Alternative Proposals for Anderson Road and Cesar Chavez Elementary School Improvements

Michael Mulhearn
(michaeljmulhearn@gmail.com)

September 13, 2025

Figure 2: In the Concept 1 presented to the community back in 2020, the bike lane is relocated to the right-hand side of the curbside drop-off vehicles.

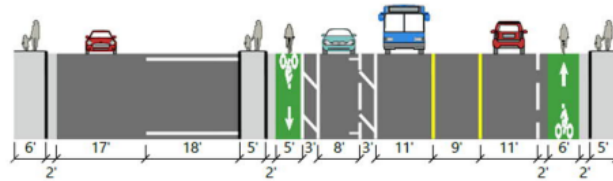
The biggest problem in the present configuration is the crossing of the bike lane with the curbside drop-off southbound on Anderson, as illustrated in Fig. 1. The minimalist approach would be to improve matters, particularly for cyclists, but leave the loading zone in or near its present location. The bike lane clearly needs to be relocated. In the Concept 1 presented to the community in 2020, the bike lane was simply relocated to the right-hand side of the passenger loading zone, as shown in Fig. 2. The concept includes a three-foot buffer to mitigate conflict between passengers being dropped off and the bikes. Other relocations are possible. Using a pedestrian scramble type signal, the southbound bike lane could be moved across the street, alongside the northbound bike lane, protected from on-coming traffic by parked cars or physical barriers. Another option is to redirect the bike lane into or around the CCE parking lot.

Figure 4: A proposal that accommodates an on-site drop-off. The essential feature is that entrance to the loading zone is limited to southbound traffic on Anderson, as the best way to accommodate the inevitable queue.

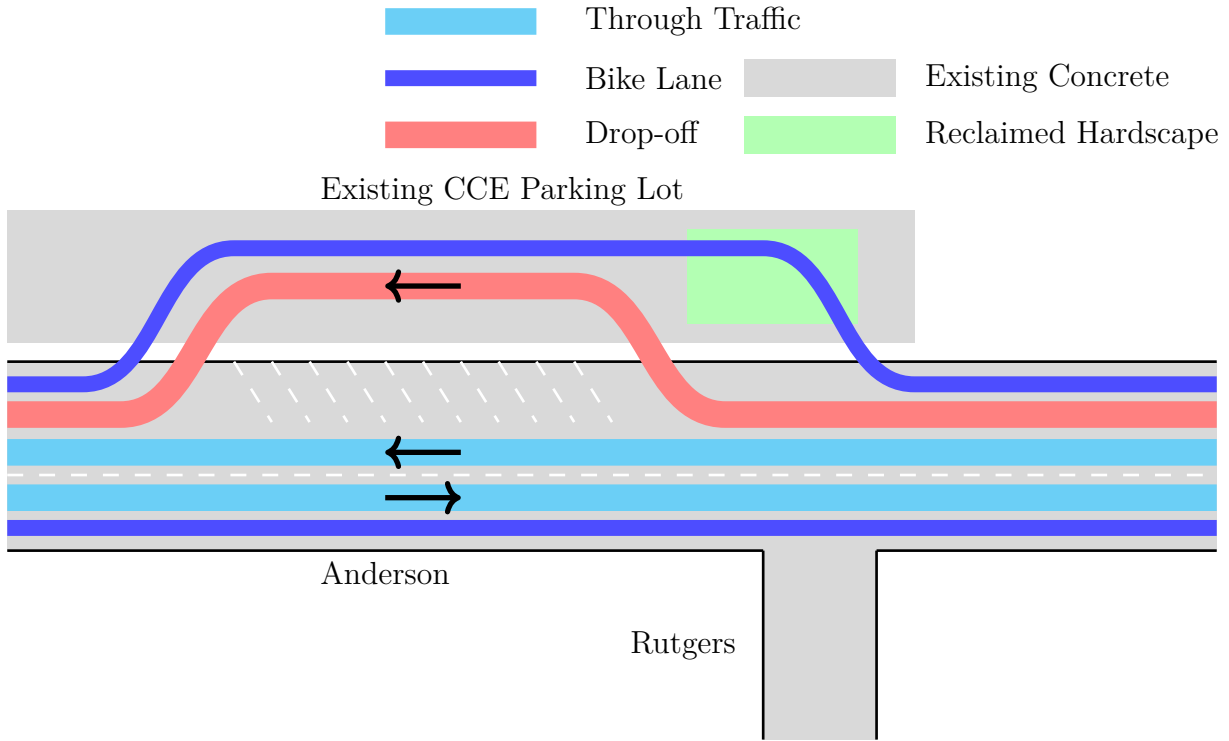
A design concept that implements an on-site passenger loading zone is presented in Fig. 4. Anderson road at CCE currently has three traffic lanes (including an under-utilized shared middle lane) plus bike lanes, parking, and a curbside passenger loading zone. This concept repurposes the shared middle lane as a dedicated through lane for southbound traffic on Anderson. This accommodates through-lanes for both northbound and southbound traffic on Anderson plus a dedicated lane for

access to the CCE on-site drop-off. The entrance to the on-site drop-off is intentionally offset from the intersection of Anderson and Rutgers in order to avoid creating a new four-way intersection. Access to the drop-off is also limited to southbound vehicles on Anderson, in order to accommodate the inevitable queue that will develop. Physical barriers could be used to prevent drivers from Rutgers or northbound drivers on Anderson from attempting to enter. To reduce demand on the on-site loading zone, off-site passenger loading zones within easy walking distance for older CCE students should be included in the design.

The bike lane is diverted in order to avoid crossing the path of the drop-off traffic. The space on Anderson freed up by relocating the passenger loading zone and bike path can be repurposed as permitted parallel or diagonal parking for CCE staff, in order to reclaim any spaces lost in the existing parking space. There is also under utilized city property further south on Anderson which could potentially accommodate additional parking for CCE and Redwood Park.

Most of the risk in this design stems from potential misbehavior by drivers. Attempts to access the drop-off from Rutgers or by a left turn from northbound traffic on Anderson can be avoided by adding physical barriers between the drop-off lane and the through lane all the way through the intersection. The on-site drop-off will inevitably be slower than the current system, and this may lead more drivers to use bike lanes, driveways, and bus stops as ad-hoc drop-off locations. This can be discouraged by moving bike lanes closer to the curbs, behind parked cars, and by bumping out bus stops. Some drivers may attempt to use free spots amongst the new parking on Anderson for drop off. This can be discouraged by making sure these spots are designated and enforced as permit only and no stopping. The constriction of through traffic at CCE should naturally slow traffic, but additional traffic calming measures could be added for this highly congested area.
